مىي بىر	PERM	IT ISSU	-D		
			Por	mit No:	Issue Date:	Ψ̈́	CBL:	
•	Portland, Maine - Building or Use Permit Application			01-0479 _Δ γ	1			01001
389 Congress Street, 04101		, Fax: (207) 874-871					336 E0	
Location of Construction:	Owner Name:				1	Phone:		
1-4 Hingham St		& Mary Alice Jts		augus St Port	la pa Me 4	AND		
Business Name:	Contractor Name			Contractor Address:			Phone	
n/a	Maine Window	w & Sunroom	71 Portland Rd. Kennebunk				2079852	
Lessee/Buyer's Name	Phone:			t Type:				Zone:
n/a	n/a		Additions - Dwellings		C-L-			
Past Use:	Proposed Use:		Permi	it Fee:	Cost of Work	c C	EO District:	
Single Family		/ build 12' x 14' deck		\$90.00	\$10,500	0.00	1	
		& enclose with 3 season sunroom.		Appioved			FION:	
	*Mail to Contr	ractor.	Denied			Use Grou	Group: M-3 Type: 5B	
]		Const K	SILED
						BOC	A BELL	EPISTIS
Proposed Project Description:		<u> </u>	1		Π	\searrow	WITH DESIGN	TANA
Build 12' x 14' deck w/ enclo	sed 3 season sunroom.		Signature: Sign			Signature	Tature Sam All

BUILDING PERMIT REPORT 32 Saugus
DATE: 9 MAY 200 / ADDRESS: 1-4 Hraphan STreet CBL: 336-E-DD/
REASON FOR PERMIT: To Construct a 12 × 14 deck w/enclosed 3 Season Sugroom
BUILDING OWNER: The Cox's
PERMIT A

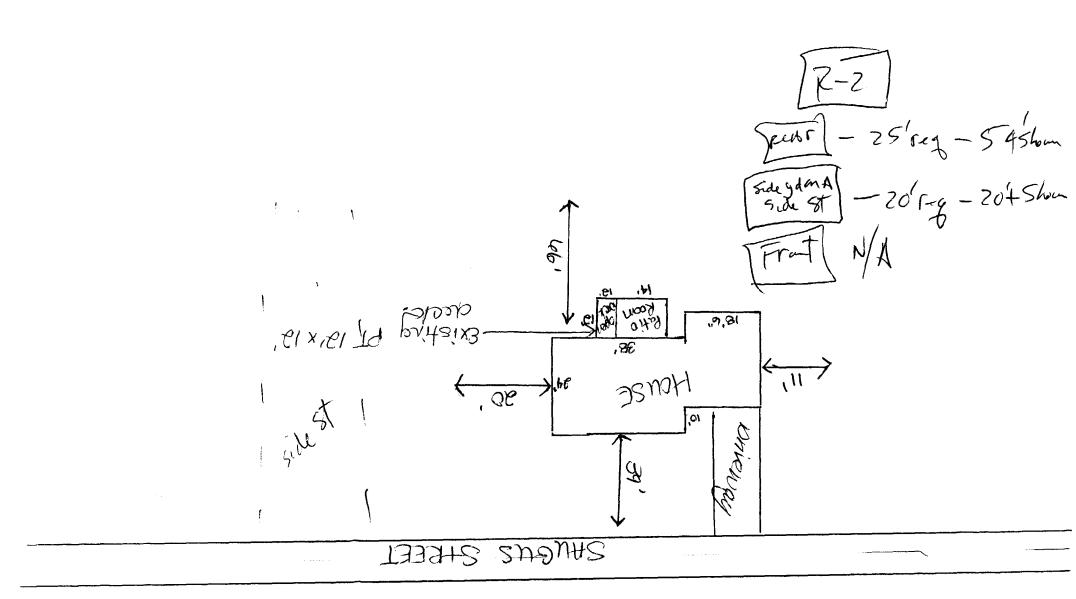
5.0.2 FIGURE 50-2 - STUDIO ROOM CROSS SECTION Load 3". 4.5" OR 6" 50' HONEYCOMB OR POLYSTYRENE ROOF PANELS ALUM. PANEL HANGER CONNECTS TO WALL STUDS 3" RAIN GUITER ----ALUM. SLIDING DOOR NPICAL 3/4" EXTERIOR PLYWOOD TEMPERED GLASS-2×10 JOISTS AT 16" o.c. SLIDING DOOR ON SILL ໍ່ ຕາ SECTION W/ DOOR FLOOR 12×BLOCKING PIECES AS EXPANDER FIXED TO DECK REQUIRED FOR ATTACHMENT in W/ NO. 14x2"-3" HEX SCREWS OF ROOM TO DECK AS PER NYLON INSERTS AT 2'-0"0.C. MANUFACTURE'S SPECIFICATIONS ÷ FLOOR (3) 2x10 GIRDER / 2 . 10 2x10 LEDGER W/JOIST HANGERS AND PRESSURE TREATED POST BRIDGING BRIDGING SECURE TO HOUSE WALL W/ 3/8" AT MO SPAN DIAM. × 5" (LAC BOLTS AT 16" "(LECO" POST ANCHOR BASE P.T. Lumber APPROX GRADE Jeg. If within stof early AT MID SPAN 18"O MAX CONC FOOTING BOTTOM OF FOOTING TO REST ON UNDISTURBED SOIL BELOW FROST LINE STUDIO ROOM CROSS SECTION (WOOD FLOOR) More Then 2' CanTikever Shall neq. design prof. report - This will req. report due to the prof. report on CanTikever
